ADDENDUM NO. 2

**MID VALLEY SANITARY LANDFILL WEST CHANNEL CONSTRUCTION PROJECT
AT THE MID VALLEY SANITARY LANDFILL**

MARCH 14, 2022

JOINT DETAIL WITH WATER STOP

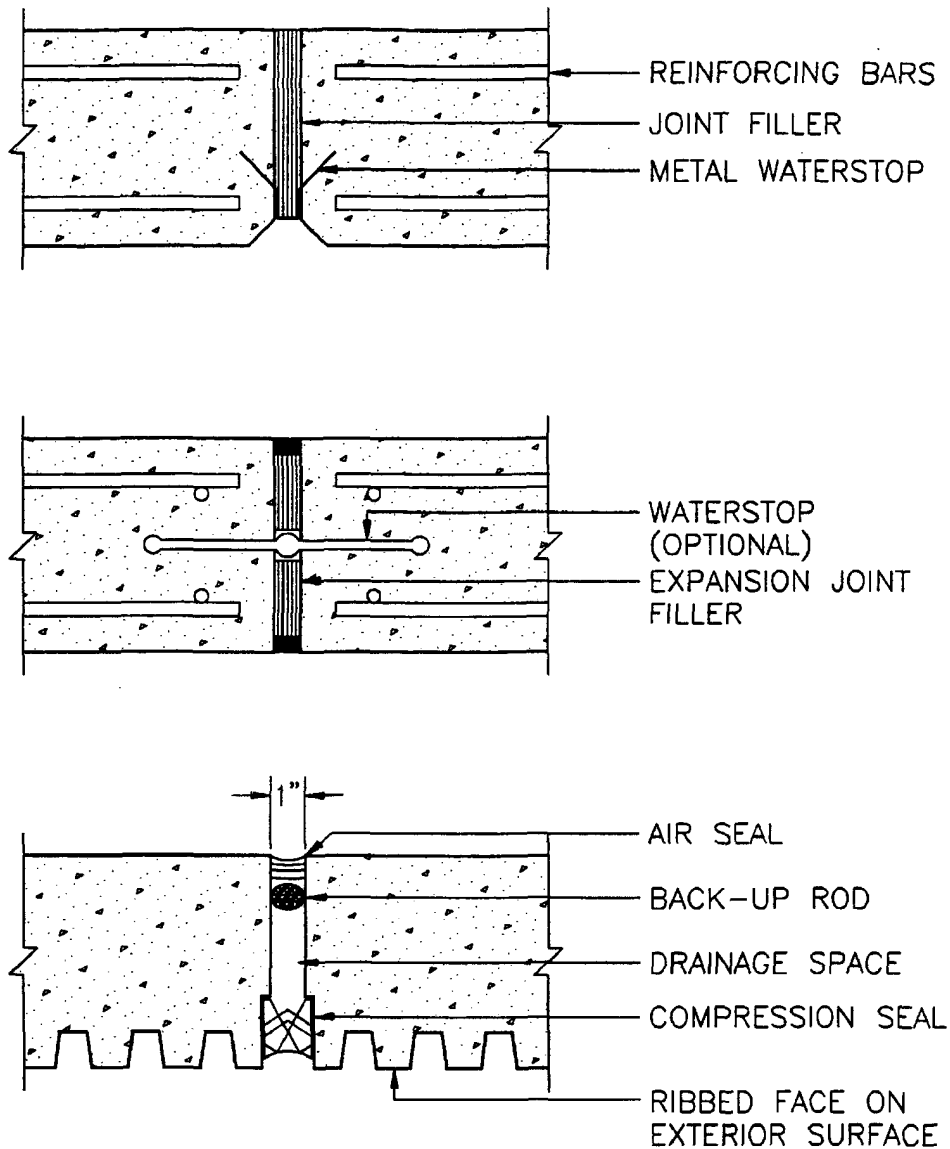
- Q3. May 4000 psi shotcrete/air-blown mortar (per Greenbook Section 303-2) be used for the channel? This would be especially helpful for the channel slopes and the connections/transitions at each end. The existing basin at the lower end was constructed with shotcrete a few years ago.
A3. Shotcrete will not be allowed.
- Q4. Please provide a detail for the transverse joints with waterstop referenced in Detail 4, Sheet 12, Note 2.
A4. Transverse joints shall be per ACI 224.3R-95 with water stops, see detail attached.
- Q5. Can you change the Stainless Steel Stop Log (Item No. 8) to a unit price with 8 each in lieu of 1 lump sum?
A5. No, stainless steel stop logs will remain a lump sum item.
